WEST WILTSHIRE PARISHES: PROPOSED WAITING RESTRICTIONS

RECOMMENDATIONS FOR AMENDMENTS TO PROPOSALS

Mead Park

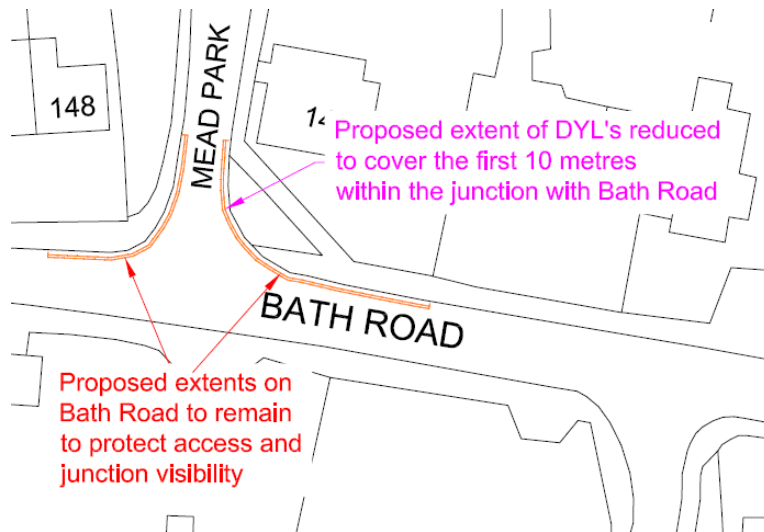
After further consideration the proposed restrictions could be shortened only to protect the crucial immediate 10 metres within the junction with Bath Road.

Devizes Road

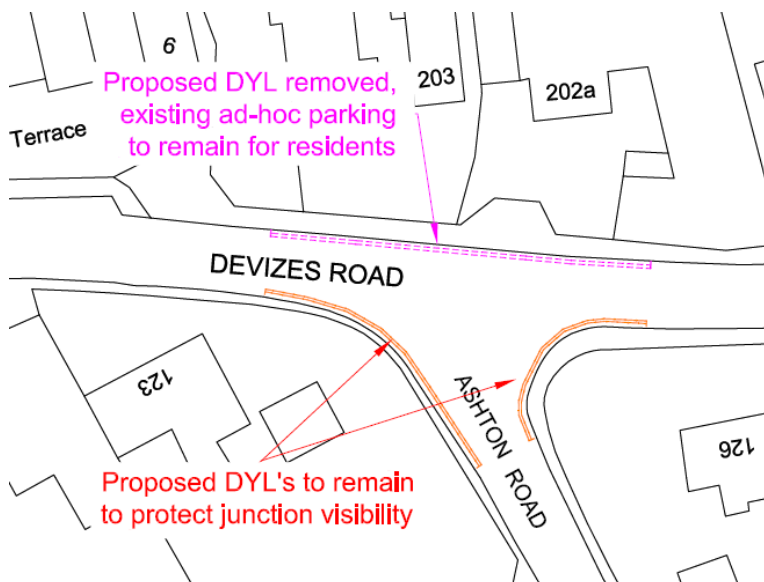
Since reviewing the comments raised during the consultation further investigation on site, it is considered that the existing parking on the north side of Devizes Road opposite the Ashton Road junction can remain, acting as a further traffic calming feature and to maintain parking availability for residents on Devizes Road. Also in recognition that with the Hilperton GAP road nearing completion, traffic volumes are expected to fall.

Hackett Place

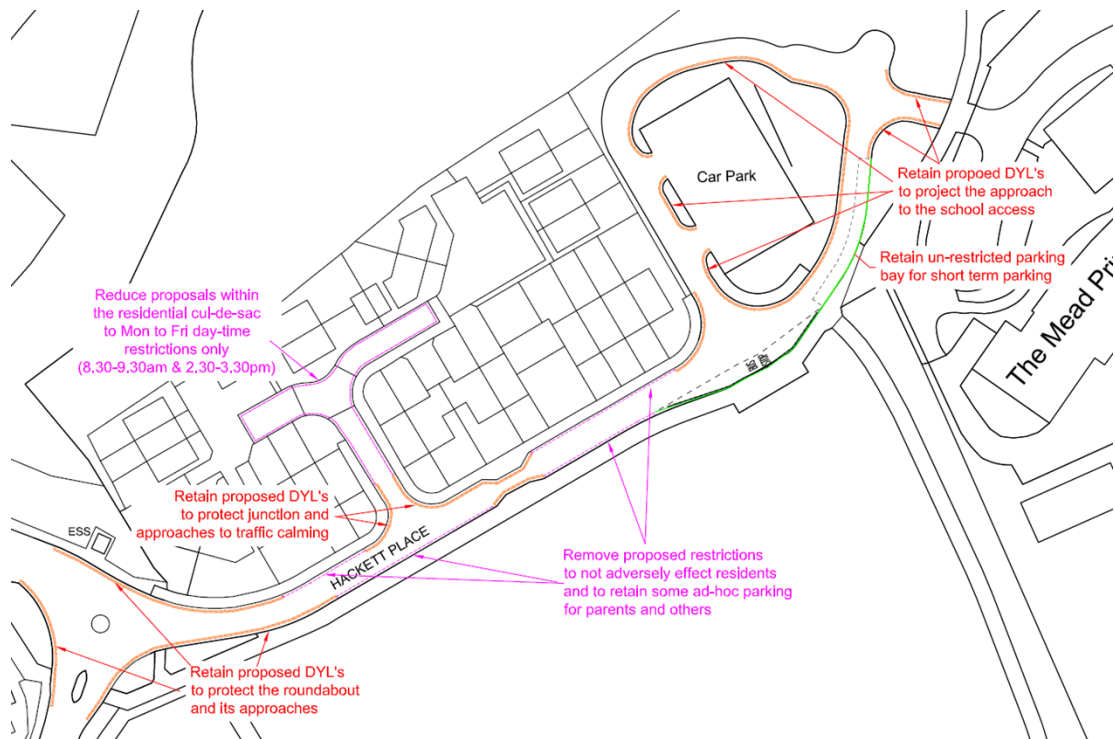
On reviewing the comments made, it is considered that the proposals could be reduced so that residents are not adversely effected, and that parents can still park in order to drop off and pick up their children from The Mead School, but not at the determent to highway safety; therefore, the proposals at key areas to protect junctions, accesses and traffic calming should remain.

The proposals within the residential area to be reduced to a day-time restriction. Thus preventing driveways being blocked by parents/carers associated with the school, but not to hinder residents out of school hours.

Beckerley Lane

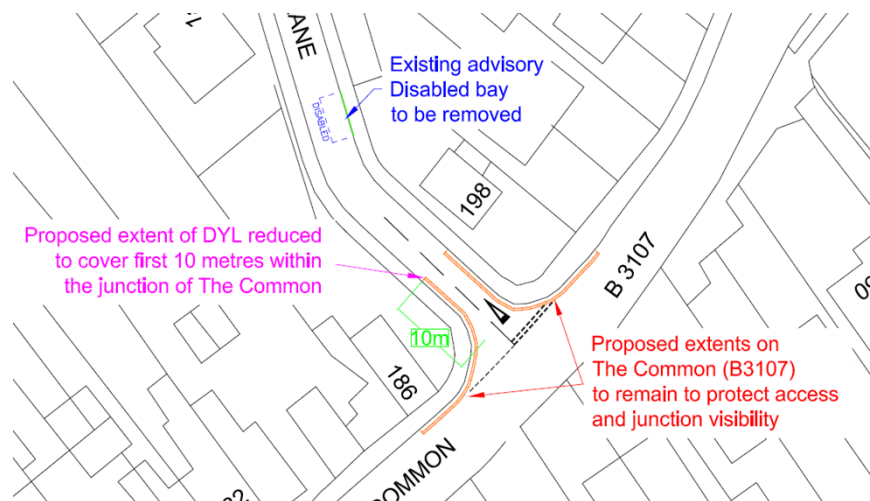
After reviewing the comments made, it is considered that the proposals could be shortened only to protect the crucial immediate 10 metres within the junction with The Common.

Blackthorn Way / Maunders Drive

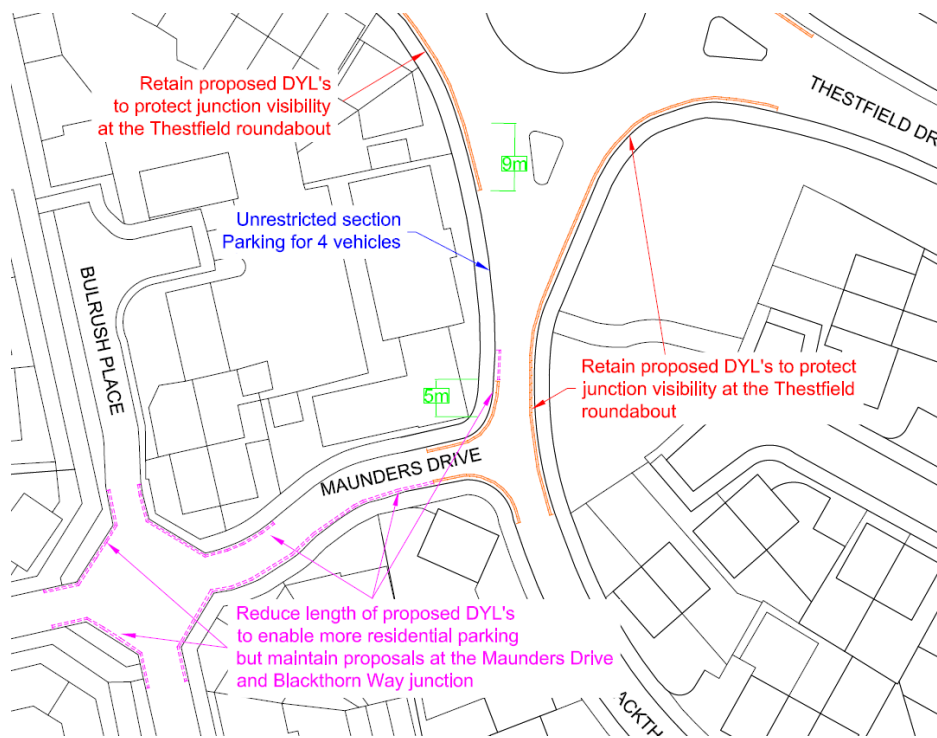
After reviewing the comments made, it is considered that the proposals could be reduced so that residents are not adversely effected, but not at the detriment to highway safety; therefore, the proposals at key areas to protect junctions, accesses and traffic calming should remain.

Bradford Road

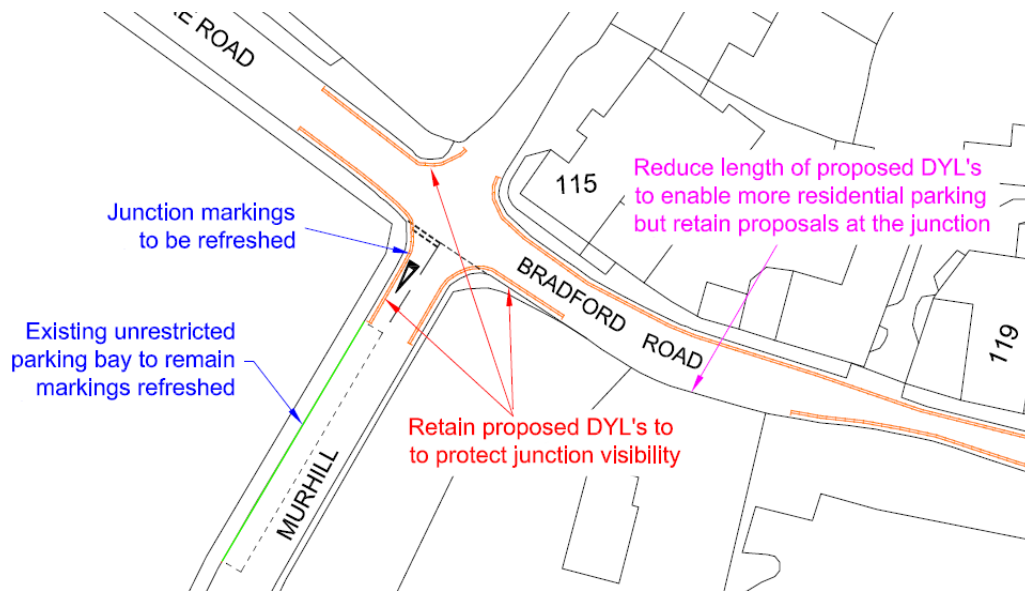
- i) To reduce proposed restrictions to enable parking for residents in the wide area east of the Murhill junction.

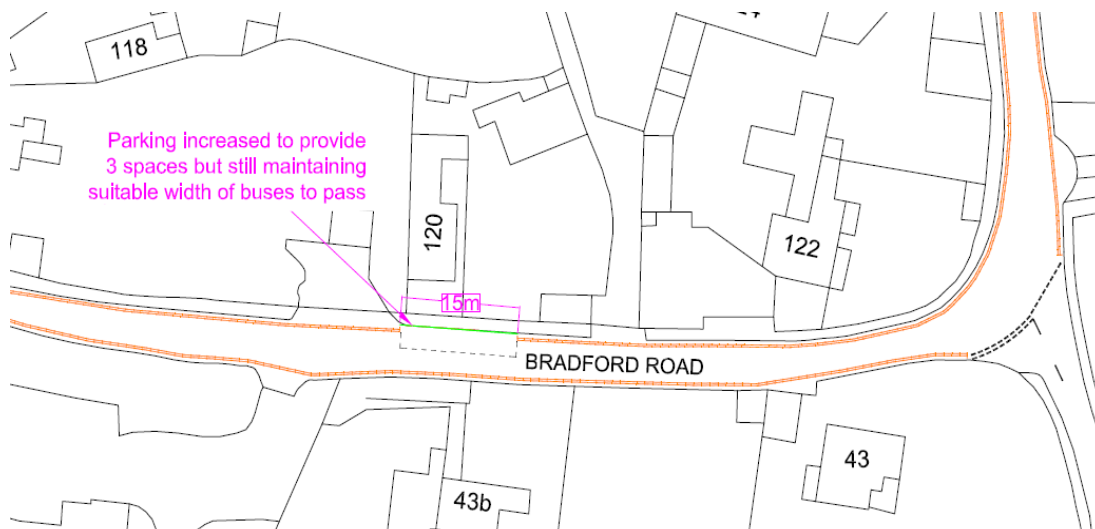
- ii) To increase the unrestricted parking area outside no.120 where the available width still allows a bus to pass.
